MILITARY SPECIFICATION SHEET

NUT, PLAIN, CLINCH AND NUT, SELF-LOCKING, CLINCH (SELF-CLINCHING, KNURLED COLLAR, MINIATURE, FLOATING, 450°F and 600°F)

MIL-N-45938/13
AMENDMENT 1
19 April 1996

NUT, PLAIN, CLINCH AND NUT, SELF-LOCKING,
CLINCH (SELF-CLINCHING, KNURLED COLLAR,
MINIATURE, FLOATING, 450°F AND 600°F)

TABLE I. Dash numbers, part dimensions and installation hole dimensions

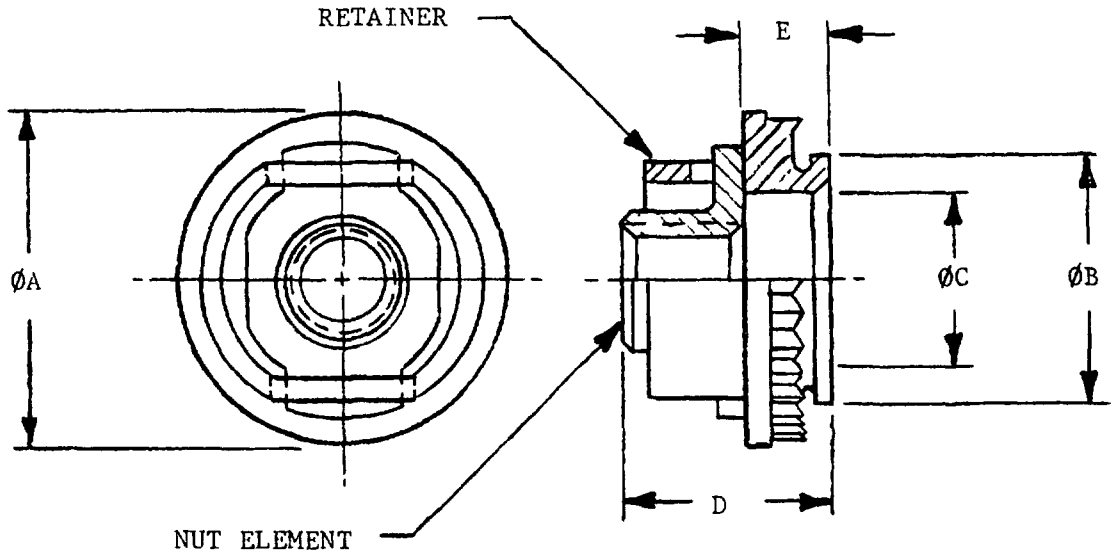
Table I, bottom line, correct ".2500-28 UNJC" to ".2500-28 UNJF".
